HISTORIC CONSERVATION BOARD AGENDA

APPLICATION FOR CERTIFICATE OF APPROPRIATENESS HISTORIC CONSERVATION BOARD PUBLIC HEARING STAFF REPORT

APPLICATION #: COA2017031 APPLICANT: Sarah Cornell

OWNER: Storied Homes OTR, LLC ADDRESS: 1532 Republic Street 081-0004-0043-00

SIGHT LINE DRAWING

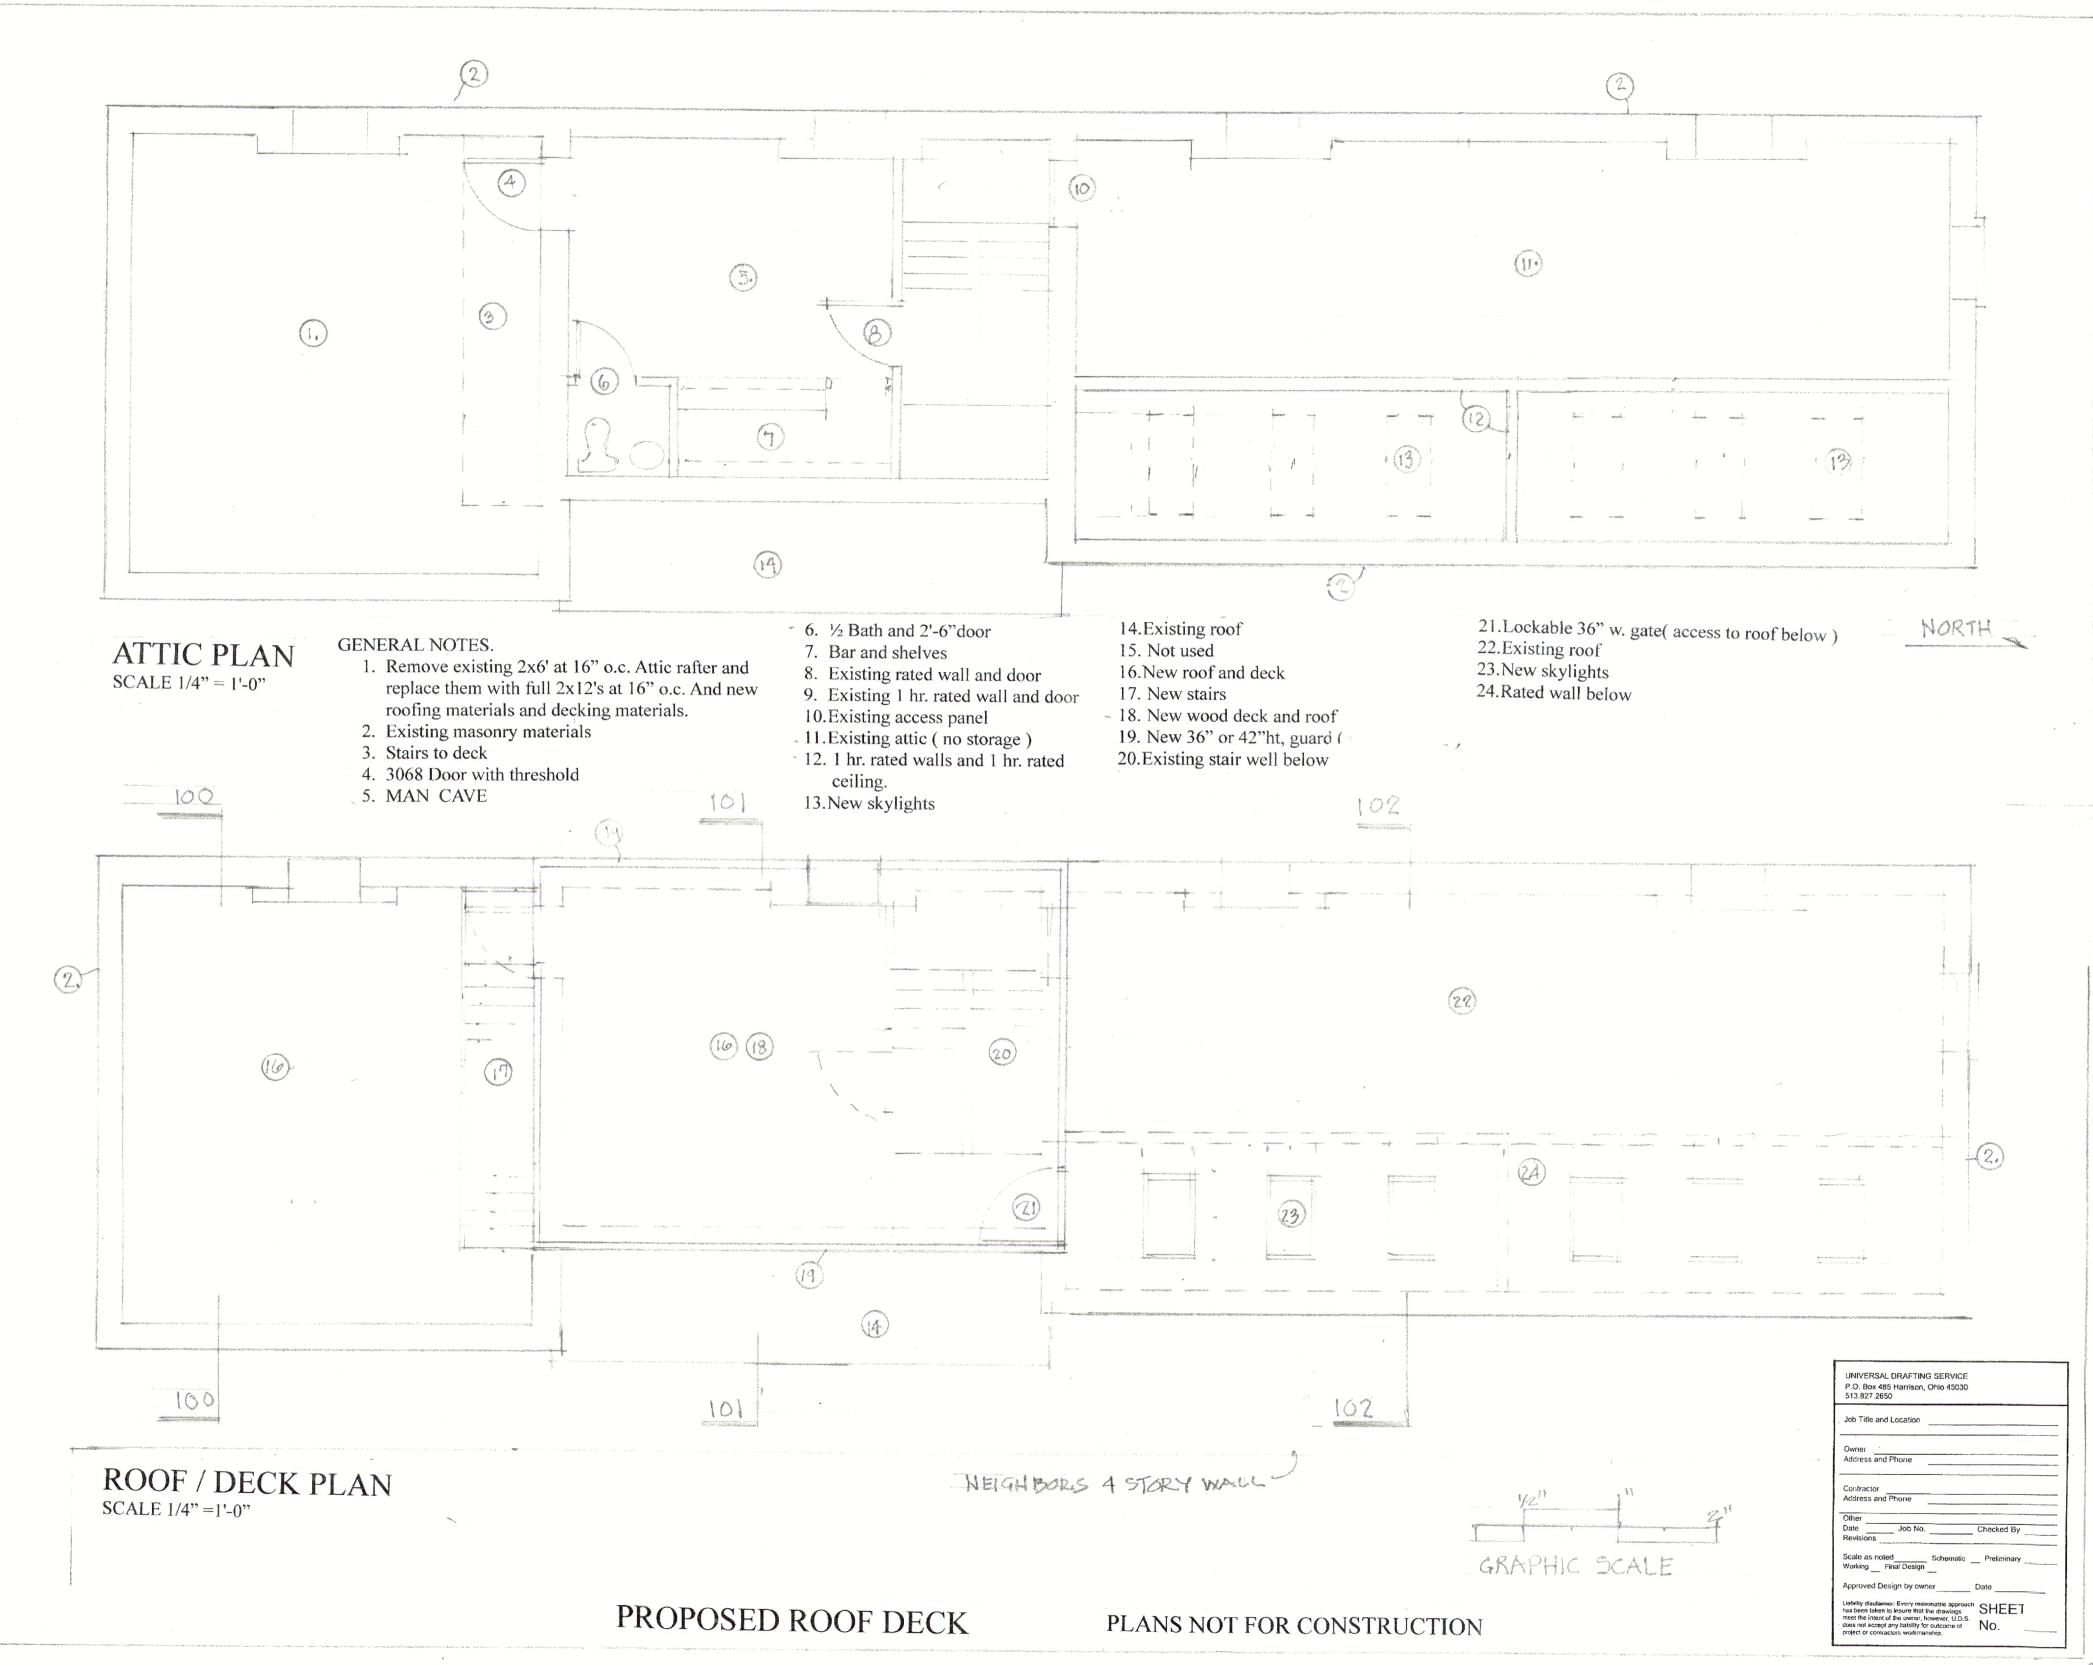
The lower deck is not highly visible from the principal façade as it is being cut into the roof and the sides showing the pitch of the roof will remain. To get access to the roof a room is being added to the middle of the roof in a dormer like fashion. Staff understands access is required for the roof, however we do feel that the minimal amount possible should be designed. This roof deck has designed two decks a lower deck and an upper deck. While roof decks are common in Overthe-Rhine a multi-level roof deck such as this is larger than what is typically permissible and staff feels that the deck should be downsized from the current design. The upper deck will be highly visible from west of the property and from the Findlay Market Parking lot. By removing the deck from the upper portion, the roof top addition would be minimal and would not go much above the west pitch of the roof. This would also bring the addition further back from the cornice as the stairs from the bottom deck to the top deck would removed. This would make the addition much less visible from the west portion of Findlay Street. The east side of the building would be hidden by 3 story property to the east along Race Street.

Roof decks should be minimal in nature and should not be highly visible. The proposed reductions will provide a deck similar to others that have been approved while not having a high visibility impact onto the building.

- A. **APPROVE** a Certificate of Appropriateness for 102 Findlay Street per plans Universal Drafting Services dated 6/2/2017 including any revisions submitted for permit subject to staff review and approval with the following condition:
 - The staircase and upper roof deck be removed from the scope of the project and just the penthouse addition and lower roof deck be constructed.
 - 2. The building permits must be issued within two years of the decision date or the Certificate of Appropriateness shall expire.
- B. **FINDING:** The Board makes this determination per Section 1435-09-2:
 - 1. That the property owner has demonstrated by credible evidence that the proposal substantially conforms to the applicable conservation guidelines.
